# **Technical Service Information**

### **GM 4T65E**

#### ELIMINATION OF THE FORWARD & REVERSE SERVO BOOST VALVES

Figure 1

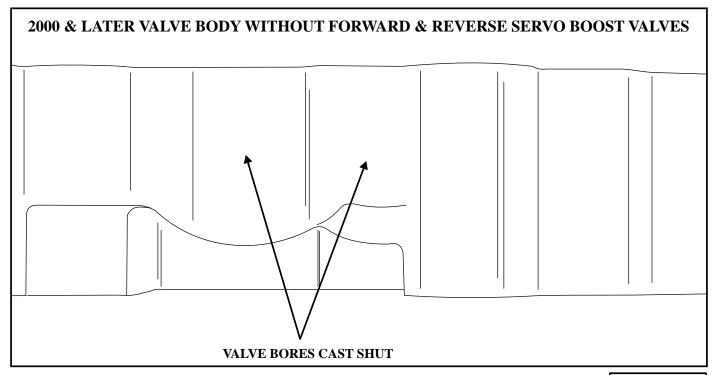
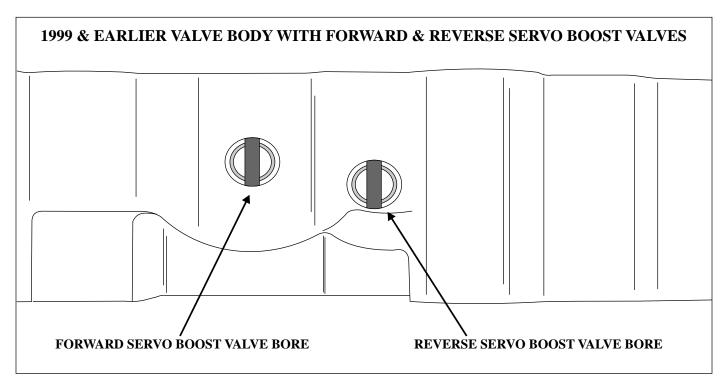
**CHANGE:** At the start of production for the 2000 model year, the forward and reverse servo boost valves were eliminated from the valve body.

The elimination of the forward and reverse servo boost valves resulted in the valve bores being cast shut, as seen in Figure 1.

The previous design valve body with the valve bores can be seen in Figure 2 and the forward and reverse servo boost valves can be seen in Figure 3.

Figure 3

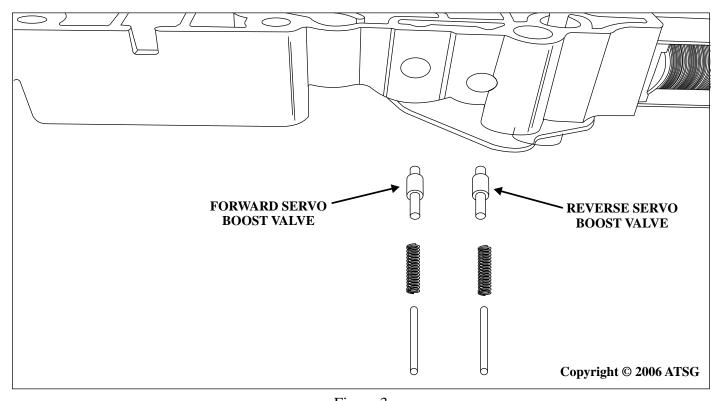
**REASON:** The purpose of the forward and reverse servo boost valves is to act as accumulators to cushion forward and reverse engagement. The valves are redundant and were therefore eliminated.
